## Report of the Chief Planning Officer

### *PLANS PANEL EAST*

**Subject: APPLICATION 11/01244/OT Outline Application for development of non food retail units, 2 car showrooms, ancillary food kiosk with associated access roads and landscaping at Land On Gelderd Road And Ring Road Beeston**

Site Plan  
 As Proposed

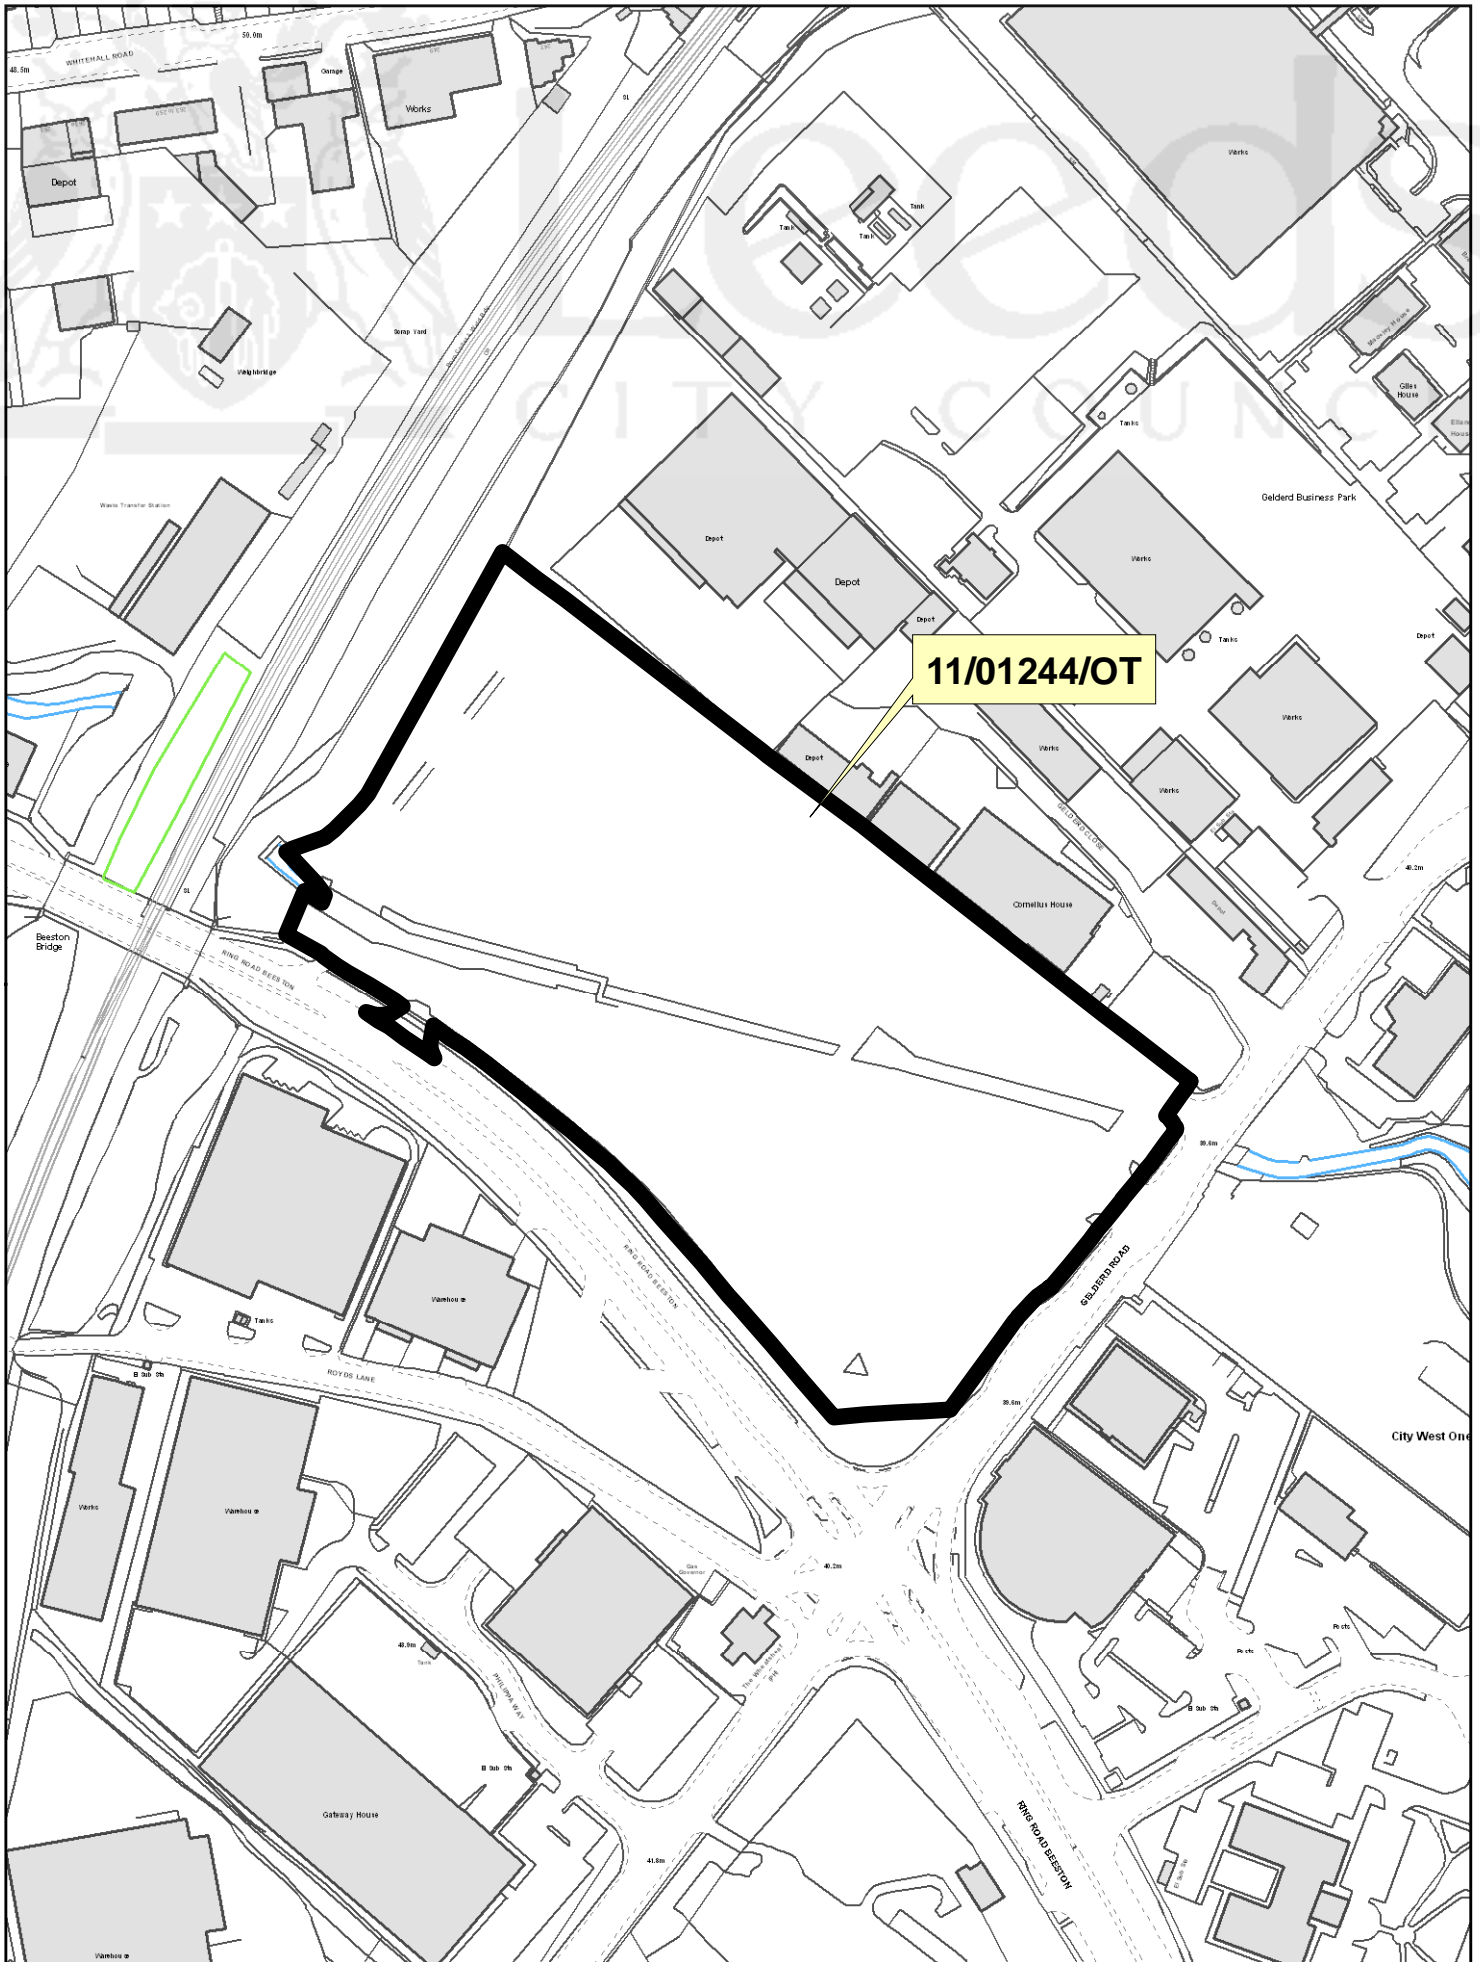
The width of the footways outside the retail units where the concentration of pedestrians would be the greatest should be increased to accommodate pedestrians, bollards, displays, etc and crossing points across the internal access roads provided. Vehicles from Ring Road Beeston attempting to park adjacent to Unit 4 would be required to make a tight 180 degree turn (opposite non food retail unit 1).

The servicing is proposed off the service road itself which could cause congestion/ obstruction of the service road as it is considered to be too narrow to accommodate vehicle movement as well as unloading and loading and therefore either needs to be widened or laybys provided.

Tracking is needed for the junction of the access road from Beeston Ring Road and the spine road outside Unit 1 to determine if a HGV can negotiate this junction on leaving the site and tracking is required to show servicing of the kiosk.

The total maximum car parking spaces therefore should be 408. 406 car parking spaces are proposed which is slightly below the maximum number recommended in accordance with the UDP Guidelines and is acceptable in principle. However the layout needs to be amended to address the issues raised and demonstrate that this will not substantially reduce the provision of car parking ratio below the maximum recommended, this needs to be addressed before the application can be supported.

- 10.16 Highways have advised that revisions are required to the service road as it is considered to be too narrow to accommodate vehicle movement as well as unloading and loading and therefore either needs to be widened or laybys provided. The applicant has provided an revised indicative layout which widens the service road.

- 10.17 Tracking is also needed for the junction of the access road from Beeston Ring Road and the spine road outside Unit 1 to determine if a HGV can negotiate this junction on leaving the site.

- 10.18 The car parking provision of 406 spaces (excluding vehicle display) shown on the indicative layout is considered acceptable for the amount of development proposed, however a revised layout is required to accommodate the highway issues set out above and demonstrate that this will not result in a significant reduction in car parking provision. The applicant is trying to address the outstanding issues.

- 10.22 210 display vehicle spaces are indicated to the front of the two car show rooms and this is considered to be excessive and a balance must be achieved with a robust landscaping strategy which will continue the green backdrop of the railway embankment and provide a strong landscaped edge to the site which will screen the large areas of car parking. It has been suggested to the applicant that the vehicle display spaces should not extend along the ring road past dealership 2 as this is when the views of the open car parking become a concern and if the number of display spaces need to be

- 10.23 It is considered that the landscape buffer to Beeston Ring Road needs to be widened as only a very minimal strip is indicated on the landscape strategy which is not substantial enough for the size of the development site and instead relies on off site landscaping along the roadside verge and corner.

- 10.24 Feature planting is referred to within the car park and trees are indicated between car parking bays, however many of these trees appear to be planted within parking bays and the landscape strategy makes no reference to planting techniques such as silva sell in support of how this car park planting might be achieved where there is minimal space for soil pits. In the absence of these details it is considered that more space must be allowed for the tree planting otherwise there are concerns that the car park planting is not achievable and will not soften the significant areas of hardstanding and long runs of parking bays.

- 10.26 It is considered that the indicative layout has a number of awkward spaces and that a more efficient parking layout could achieve the increases in landscaped areas that are required, together with the reduction or reorganisation of vehicle display bays. As the overall development of this site is maximised and alterations to the landscaping at the site could in turn affect the amount of parking provision provided, it must be demonstrated as part of the indicative layout that an acceptable balance of landscaping and car parking/ development can be achieved on this site before outline permission can be granted for the amount of development that is proposed.
